Modifikationskit für Fokus- und Radial-regelkreis für A730
(Nachrüstsatz 20.050.730.01)
Modification kit for focus- and radial control circuit for A730
(Up-date kit 20.050.730.01)

SI 127/89 d/e 10.85.7030

Einführung neuer Servoelektronik
Introduction of new Servo electronics

SI 150/91 Order Nr. 10.85.7260 (Ed. 1191)

SERVO BOARD 1.630.051.00 ⟶ .82

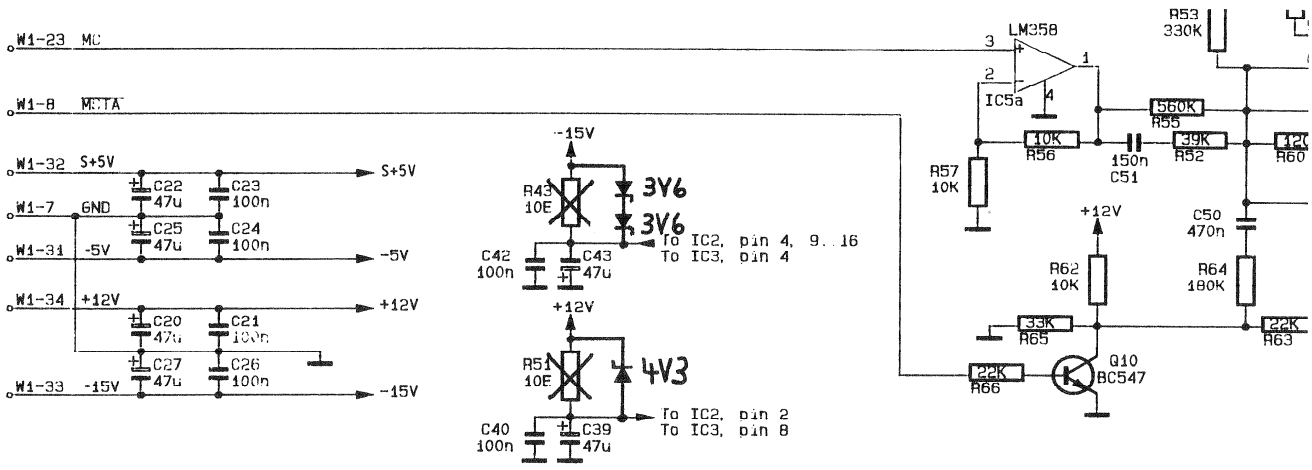
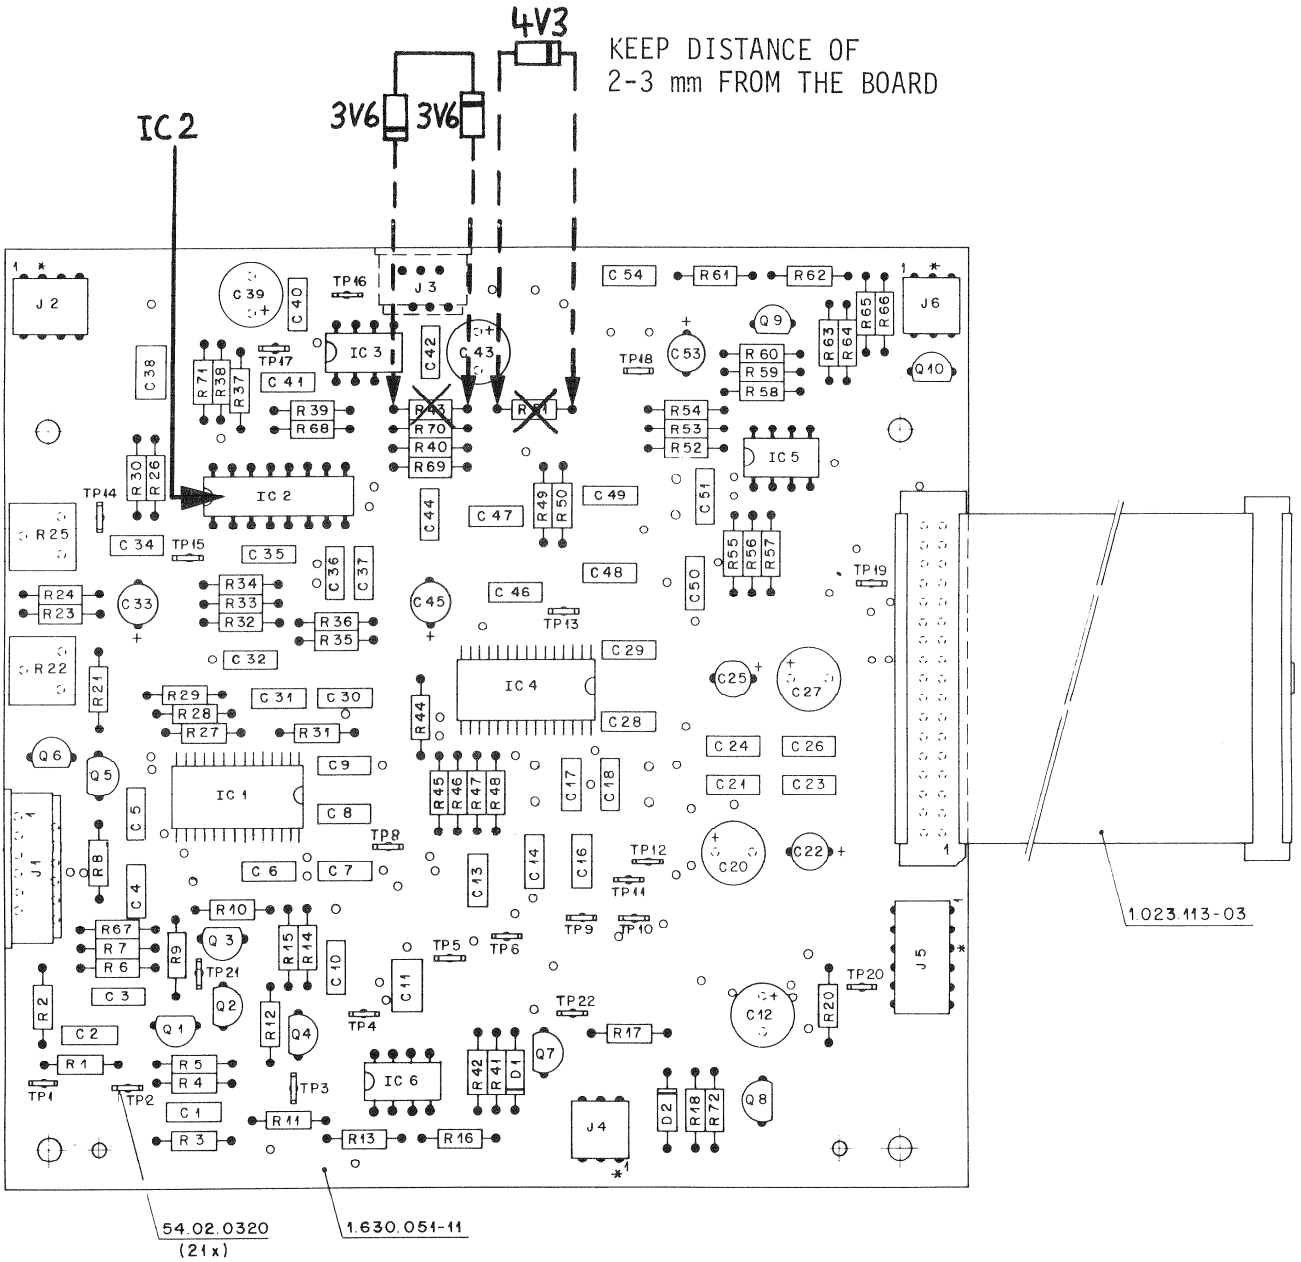
Replace resistors R43 and R51 on SERVO BOARD 1.630.051.81 by Z-diodes and put a heat sink onto IC2 according to the instructions below.

Unsolder resistors R43 and R51 and replace them by the enclosed Z-diodes according to the diagram on the next page.

Solder two Z-diodes 3V6 (50.04.1205) instead of R43 in series.
R51 is replaced by the Z-diode 4V3 (50.04.1207).

Apply to the housing of IC2 a small amount of thermal joint compound and attach the heat sink (1.010.081.50) with the enclosed clip (use a pair of tweezers).

The SERVO BOARD 1.630.051.81 changes its index to 1.630.051.82 (sticker is enclosed).

MAIN BOARD 1.630.052.20 ⟶ .21

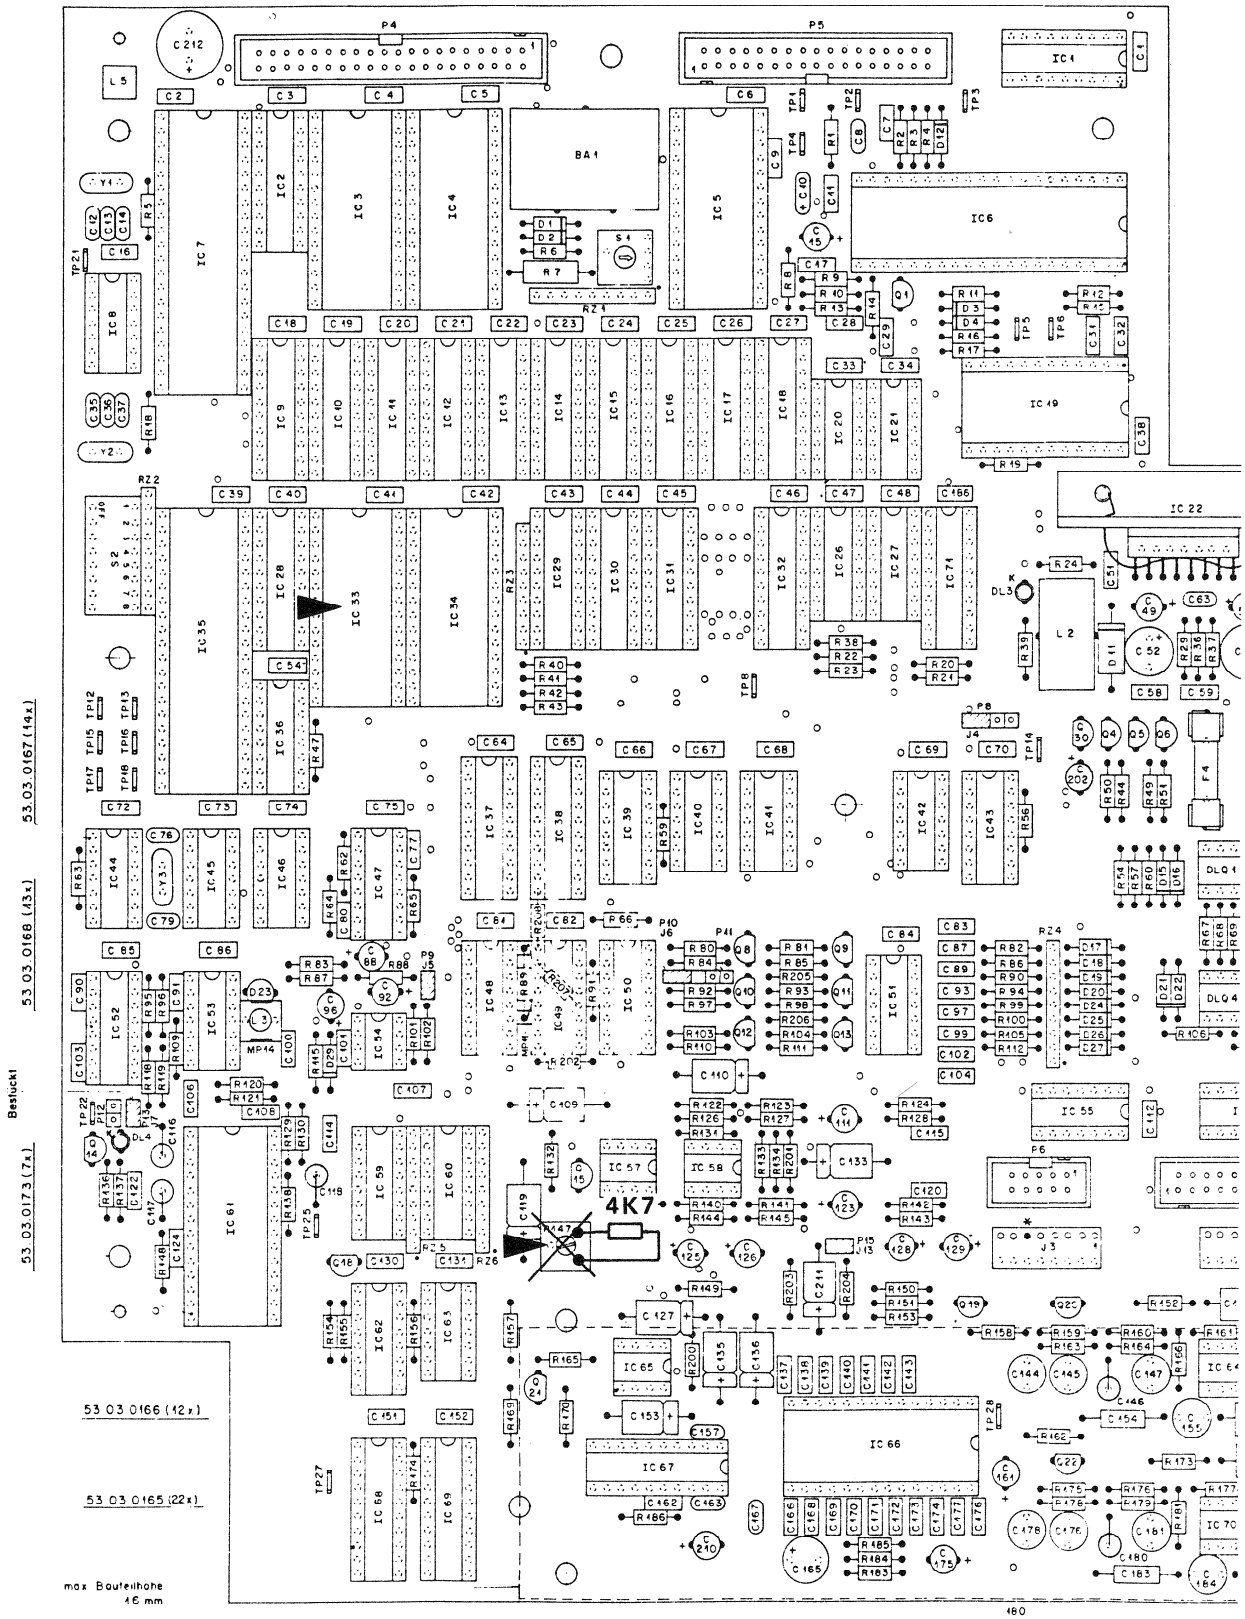
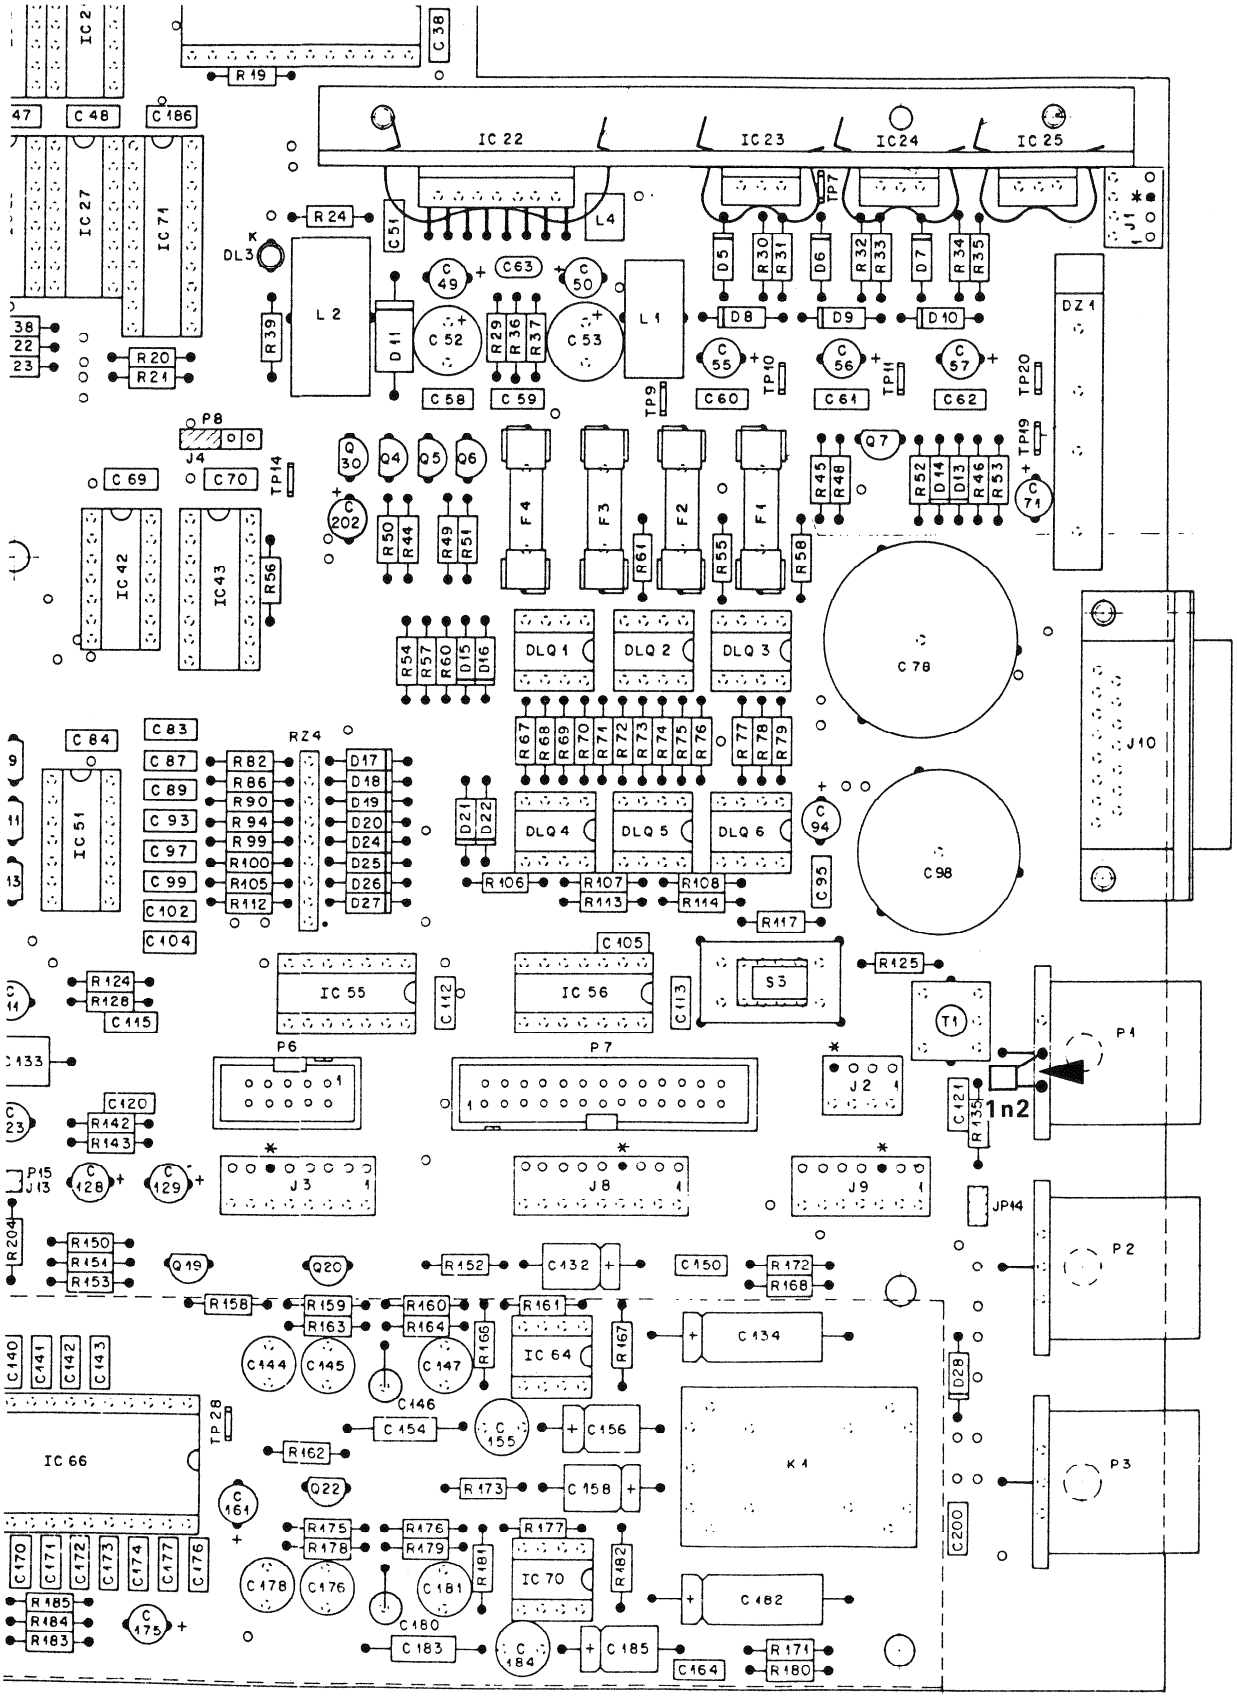
Replace IC33 (Servo software) on the MAIN BOARD by the EPROM 1.630.066.21.

Replace potentiometer R147 (volume control for monitor, headphones and variable outputs) by a 4k7 resistor (57.11.3472).

Solder a capacitor 1n2 (59.32.2122) between pins 1 and 3 of the digital output (solder side).

The index of the MAIN BOARD 1.630.052.20 changes to 1.630.052.21 and the hardware-sticker from 20 to 21 (stickers enclosed).

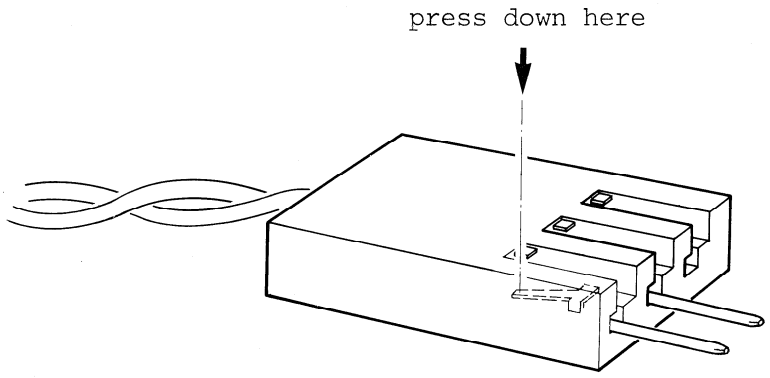
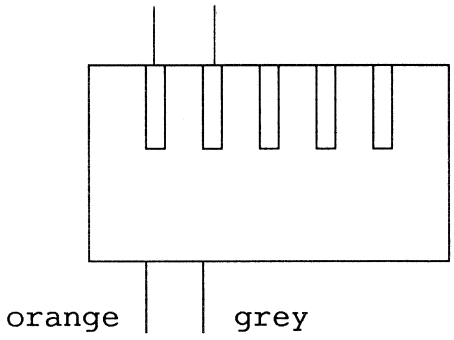
On the component side, the 3-pole CIS-socket J4 was replaced by a 5-pole socket.

Use the supplied 5-pole connector at position J4.

Pull the grey and orange wires (connection to the lock-solenoid) from the plug's shell by slightly pressing down with a screw driver the locking tongues of each wire (see drawing).

Bend the locking tongue of the grey and orange wire into their original position and put them according to the drawing below into the 5-pole plug-shell. Make sure the pins are locked.

MAIN BOARD 1.630.052.21→ 23
DECODER / MODULATION DETECTOR SECTION

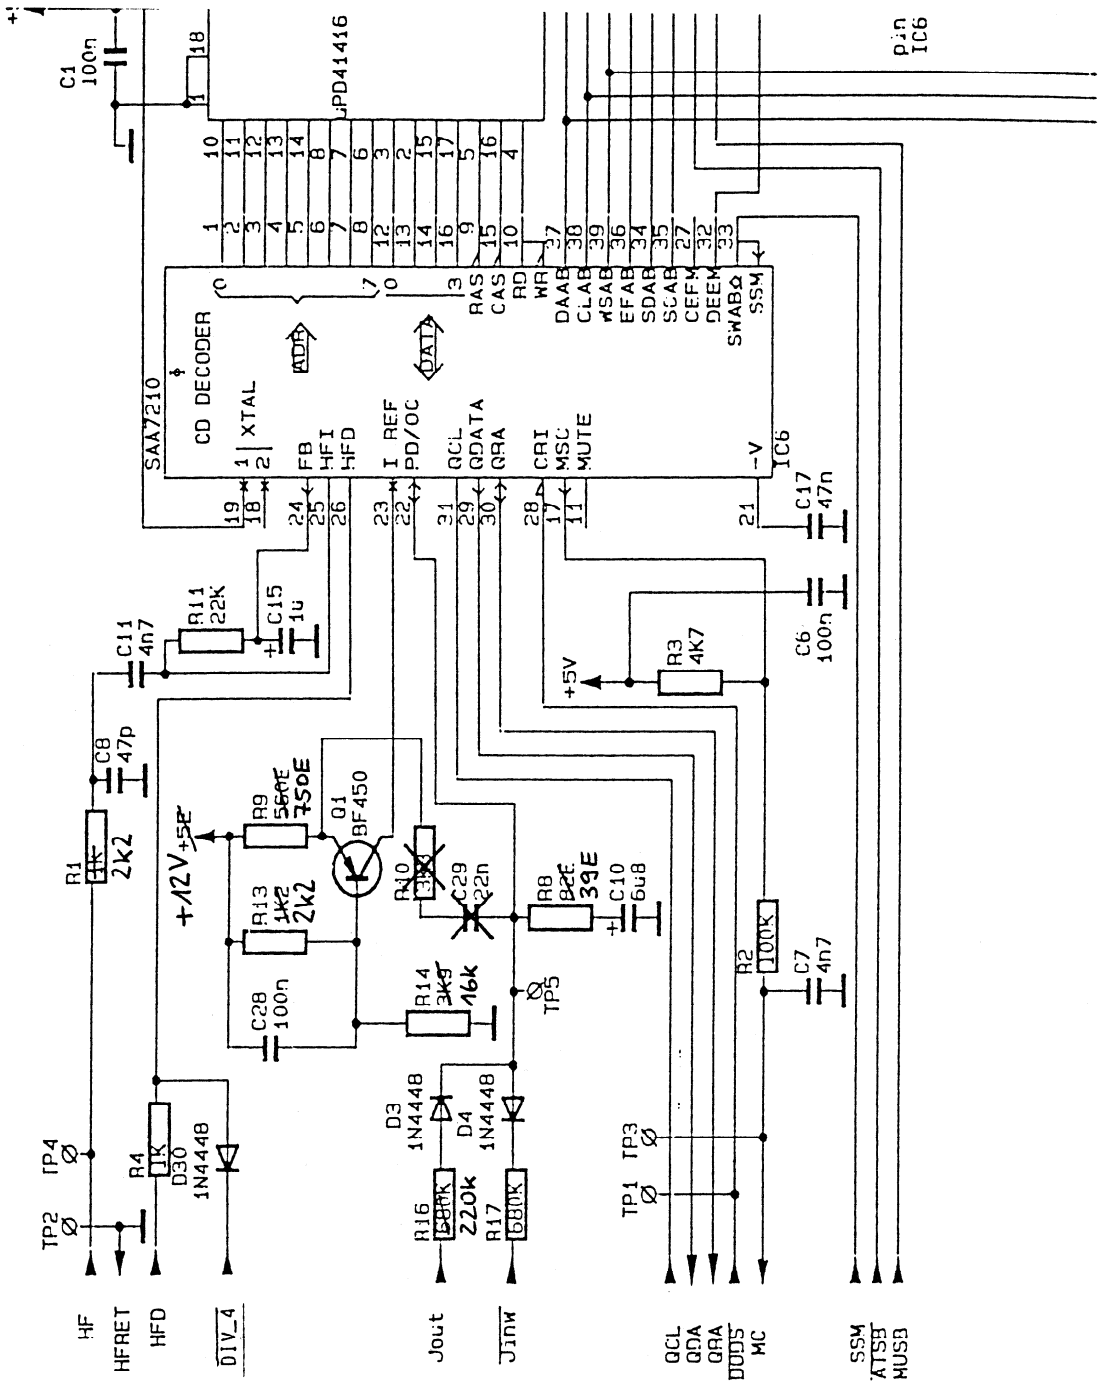
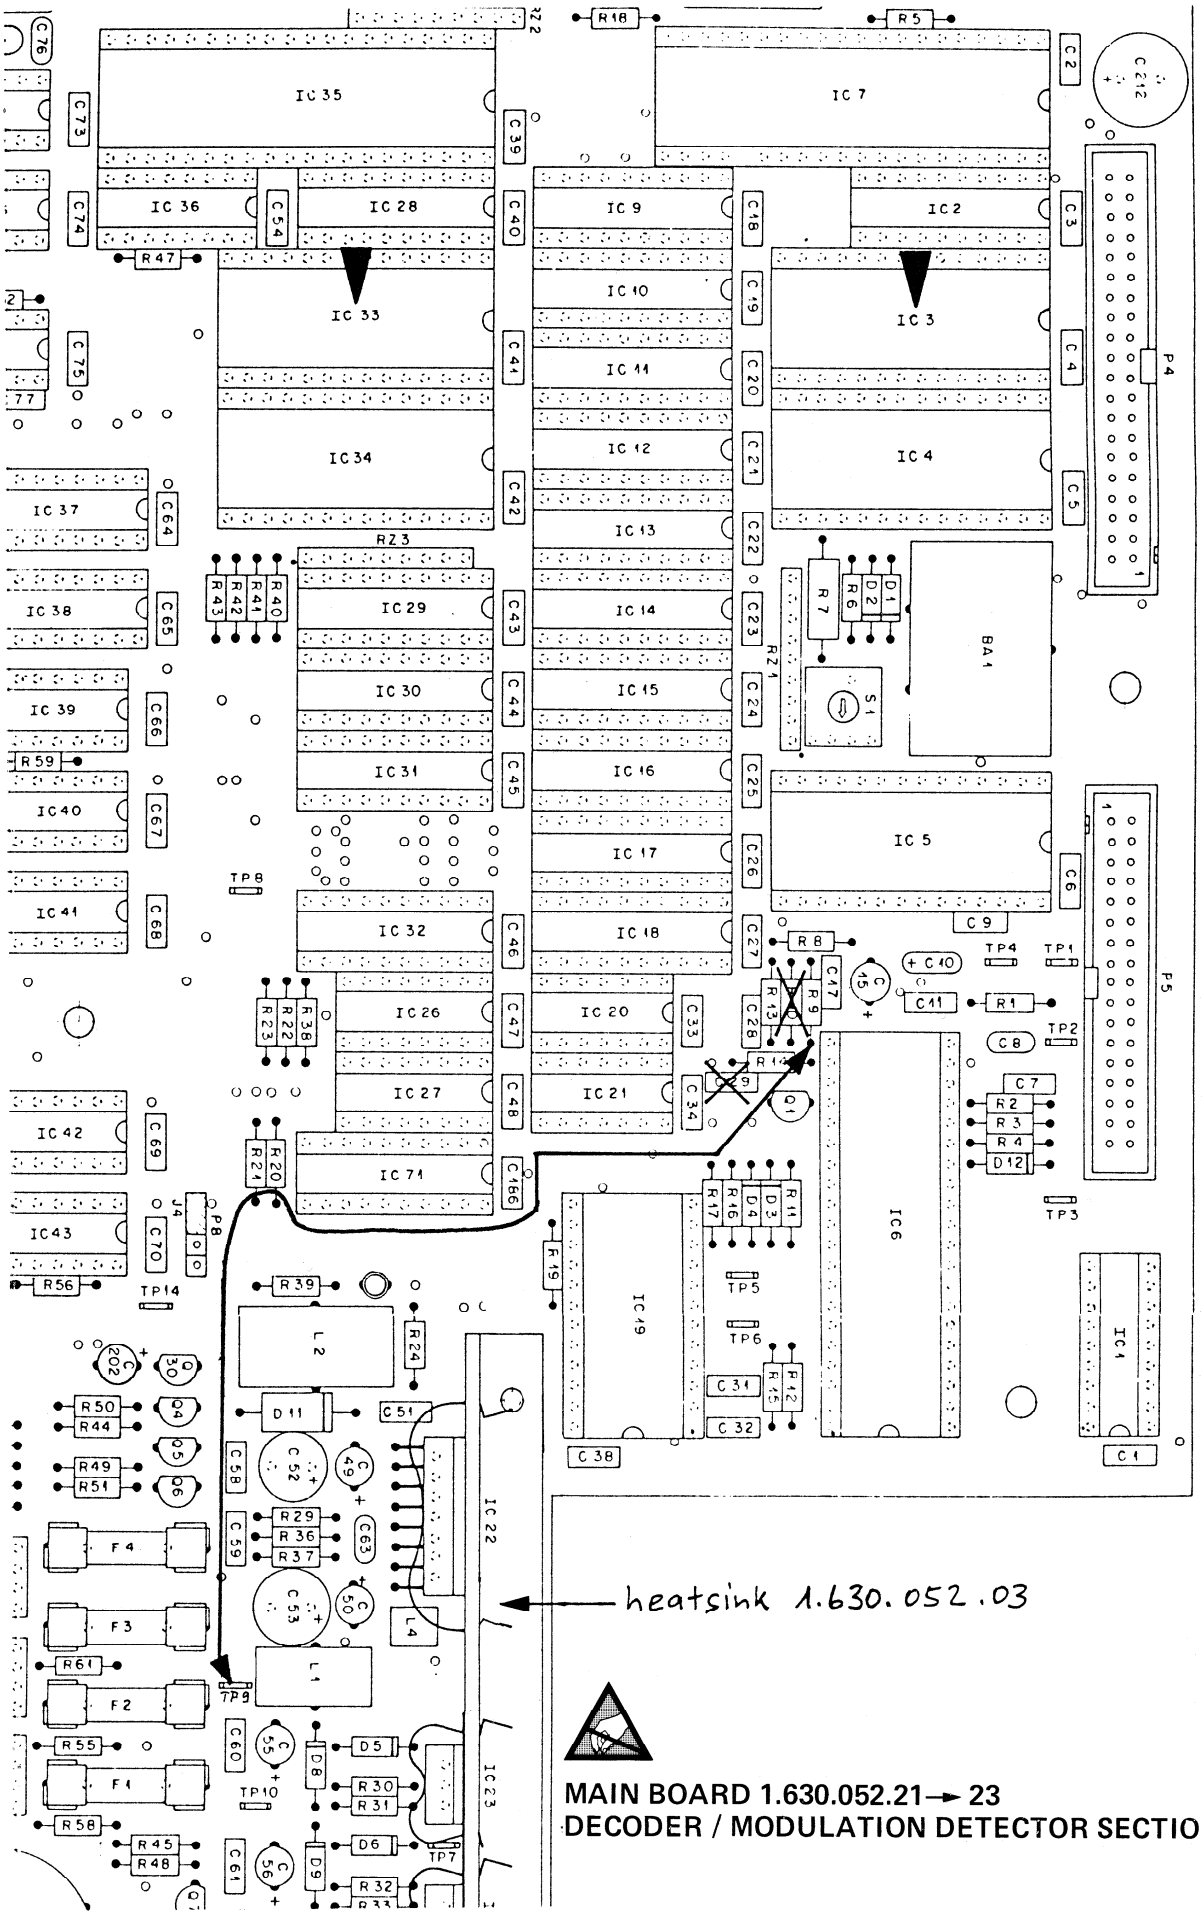
- MAIN BOARD aus dem Gerät ausbauen
- R10 (3k3) und C29 (22n) entfernen
- Folgende Bauteile werden geändert:

R1 (1k)	wird ersetzt durch	2k2 (57.11.3222)
R8 (82E)	wird ersetzt durch	39E (57.11.3390)
R14 (3k9)	wird ersetzt durch	16k (57.11.3163)
R16 (680k)	wird ersetzt durch	220k (57.11.3224)

R9, R13 und C28 inkl. wire wrap Draht sind vorgefertigt und müssen gemäss Fig. 1 und Fig. 2 auf Seite 18 eingebaut werden. Der Draht wird also auf TP9 (+12 V) geführt.

- Potentiometer R147 wird durch einen Widerstand 4k7 (57.11.3472) ersetzt --> grössere Verstärkung im Monitorpfad

- Am digitalen Ausgang wird ein Kondensator 1n2 (59.32.2122) zwischen die Pins 1 und 3 gelötet (Lötseite) --> Verminderung von Störstrahlung

- IC 3 (1.630.065.20) wird ersetzt durch 1.630.065.22 (CONTROL SOFTWARE)
- IC 33 (1.630.066.20) wird ersetzt durch 1.630.066.23 (SERVO SOFTWARE)
